The York Potash Harbour Facilities Order

Planning Inspectorate Reference: TR030002

Summary Written Representation of Tata Steel UK Limited and others (Reference: YPOT - AFP050)

Written Representation of Tata Steel UK Limited and others (Reference: YPOT - AFP050)

Figure 1 - Services Plan relative to Bridge 20 (Hot Metal Rail)

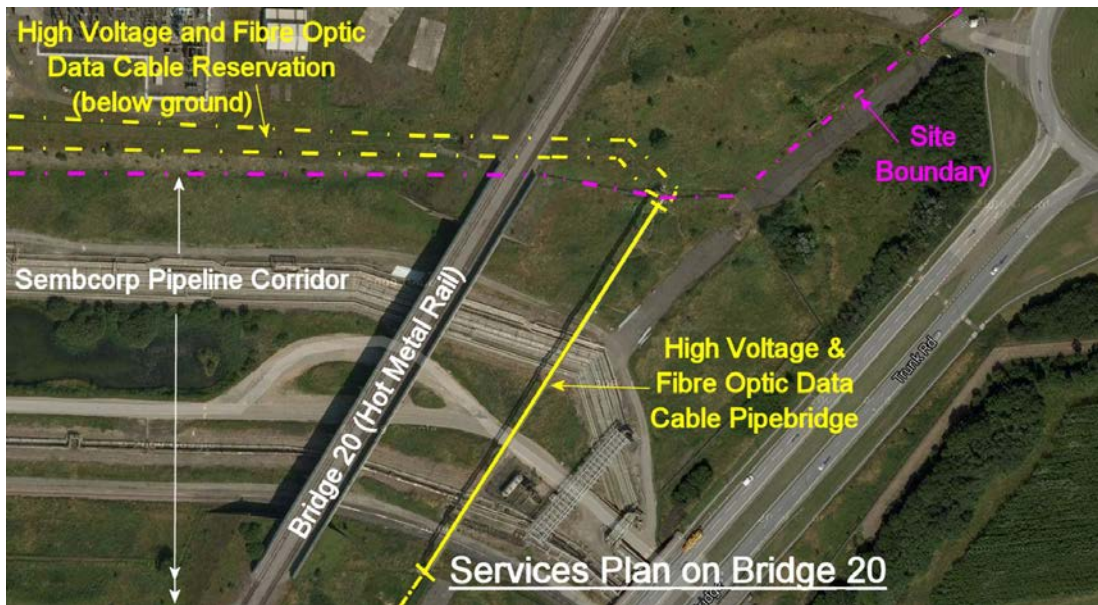
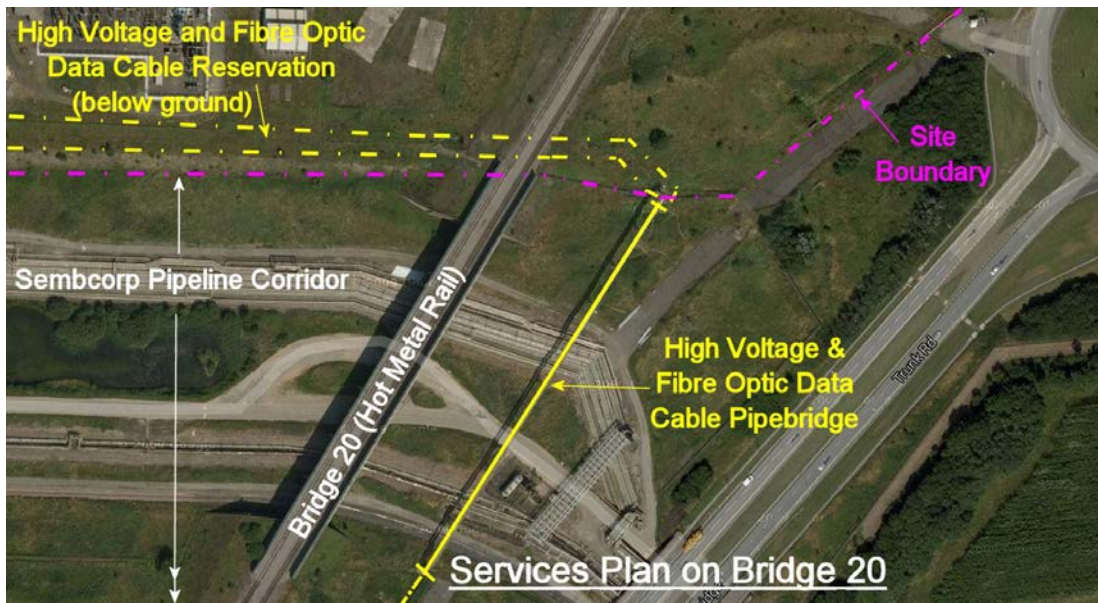
- 2.16 The proposed conveyor system passes over the HMR at "Bridge 20" which in itself passes over one of the main pipeline corridors (Sembcorp) carrying services and materials (chemicals, etc.), including the Breagh gas pipeline. Tata and SSI have the benefit of rights for the HMR and bridge to pass over the Sembcorp corridor. Tata/SSI have high voltage and data cables running parallel alongside the Sembcorp corridor's north boundary, and at

positions shown on the Figure 1. These run over the top of the Sembcorp corridor at Bridge 22 (see below and Figure 2) and also the pipebridge structure east of Bridge 20.

- 2.22 According to the promoter's latest drawings the proposed maximum height from the HMR to the underside of the conveyor structure would be 7.85m. Although this gives sufficient clearance for the locomotive and torpedo carrying the liquid iron to pass under the conveyor, this restricted height would be an issue in the event of a derailment on the HMR.

- 2.23 A derailment on the HMR at or near to Bridge 20 causes significant problems, particularly where both routes are blocked, if the conveyor is in place as access put right a derailment would be severely restricted/hampered by such an overhead structure. This is a potential works closure event for SSI.

- 2.32 The current derailment strategy on Bridge 20 would be to use large cranes to lift and re-rail torpedoes.
- 2.33 As explained, the conveyor crosses the Hot Metal Rail above the northern span of a multi span underbridge over the Sembcorp corridor.

- 2.34 In doing so the conveyor is routed above the 'Breagh' gas pipeline and therefore in a zone already restricted for positioning crane outriggers.
- 2.35 Jacks cannot be used on the bridge deck and the combination of the deck construction, orientation of the derailment and adjacent obstructions such as the linklines to the south may preclude pulling the wagon. Consequently cranes could well remain the only option. Two

- 2.36 The proposed conveyer would become a huge obstruction to any planned lift. Also there would be an increased liability to SSI due to the risk from a possible hot metal spillage damaging the support structures for the proposed conveyer structure.
- 2.37 It is likely that if a derailment occurred under the conveyer then the conveyer span would need to be removed before the wagon could be lifted.
- 2.38 In short, the positioning of the conveyer structure over the Hot Metal Rail, its bridge and the Sencorp corridor gives rise to a significant risk of expensive operational disruption to all parties, together with associated health and safety risks. Accordingly, it would be far preferable for the conveyer to take an alternative route to avoid the HMR and/or the Sencorp corridor, or, if no alternative route is possible to run under the HMR and bridge.

Figure 2 - Services Plan relative to Bridge 22 (Blue Main Route)

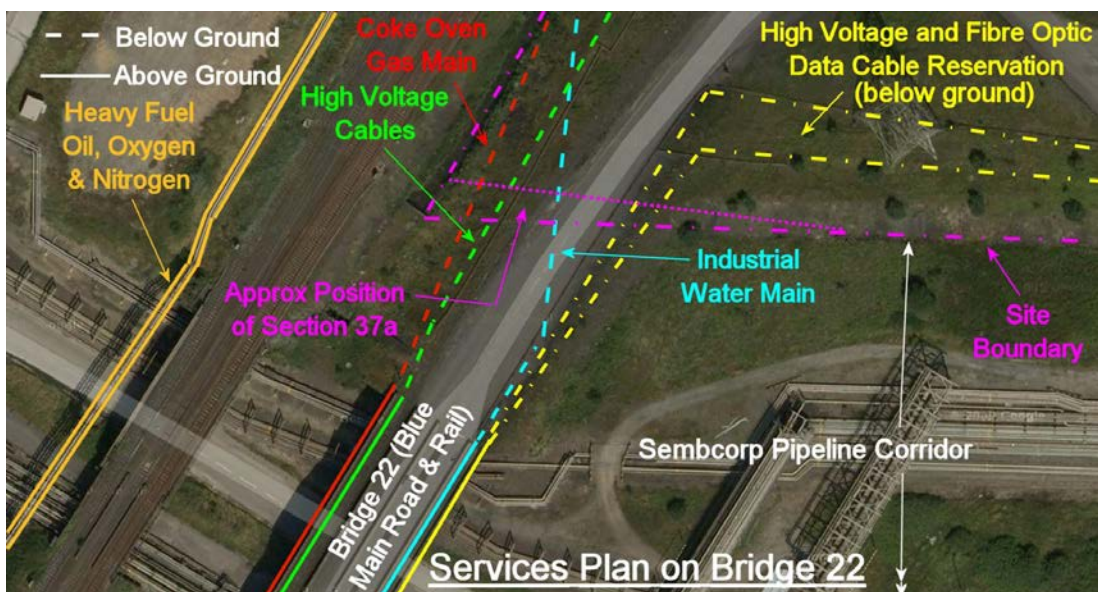
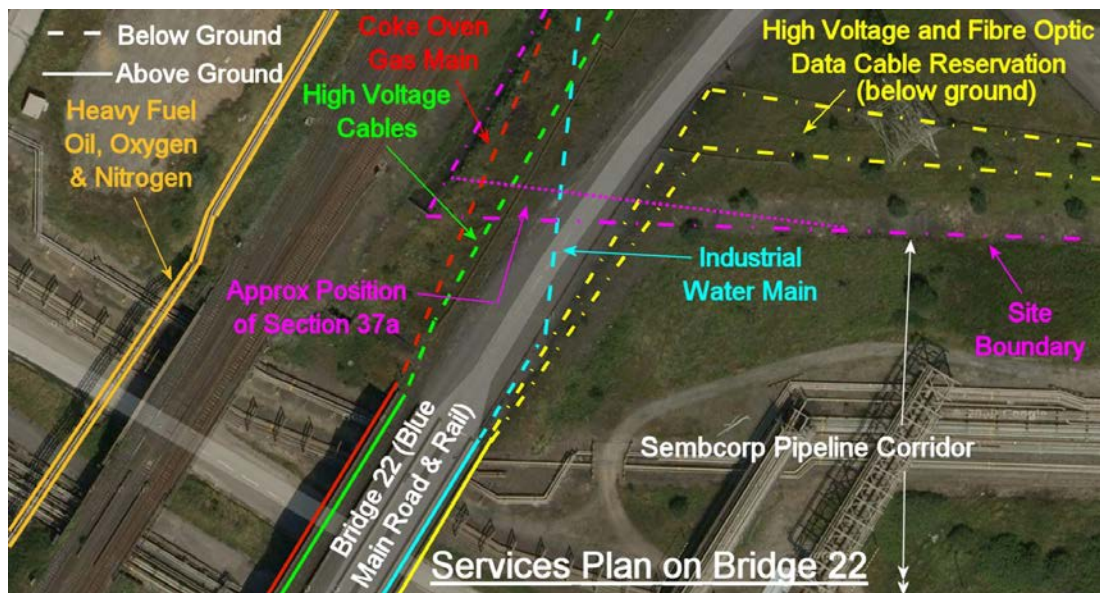
- 2.39 The proposed conveyer also passes over the "Blue Main Route" at "Bridge 22". The Blue Main Route extends from the Coke Works at South Bank to the RBT and comprises both road and freight rail together with crucial services. The route is owned by Tata and to some extent SSI with its use shared by Tata, SSI and RBT plus a large number of on-site contractors and businesses. As for Bridge 20, Tata and SSI have rights to run the route and bridge over the Sencorp corridor. Bridge 22 passes over the Sencorp corridor. This is a top-tier COMAH site.

- 2.46 There is a risk of increased liability from possible HGV & quarry type vehicles leaving the road and impacting on the conveyor supports, also increased difficulty for recovery of said vehicles.

- 2.49 The current proposed height of the conveyor crossing at the point it oversails the Blue Main Road is 8.24m (minimum) from the top of the road surface to the underside of the conveyor structure. Tata's Teesside Site is currently used to transport abnormal loads from the river Tees (PD Ports) to the public highways if access cannot be gained down Tees Dock Road. One of these abnormal load routes is to exit via Redcar Wide Load gate (next to the Redcar Main Entrance). This route takes the abnormal load over Bridge 22 and will pass underneath the proposed conveyor. The conveyor clearance height of 8.24m would set a limitation for the height of future abnormal loads which we currently do not have. This is likely to require significant alternation to other entrances to allow abnormal loads to access the Lackenby site by other routes. This has not been discussed or designed with the promoter (see Consultation at Section 3 below) but is likely to require significant expenditure.

- 2.52 It should further be noted that a large services corridor consisting of High Voltage cables, plus the main fibre optic data cables for the Lackenby Site runs adjacent to the perimeter of Tata's land next to the Sembcorp Corridor border from Bridge 20 to Bridge 22. This runs very close to Plot 37a and any restrictions to this section of land would inhibit possible future expansion of this services corridor. These services must also be protected from the construction of the supporting structures for the conveyor.

- 2.53 In addition, Plot 37a also contains the main Coke Oven Gas Main, Industrial Water Main, plus further High Voltage cables which run from the Redcar to Lackenby Sites alongside Blue Main Route and which run under the proposed route of the conveyor. The proposed scheme cannot restrict access and maintenance of these critical underground services. The location of these services must also be protected from the construction of the supporting structures of the conveyor.
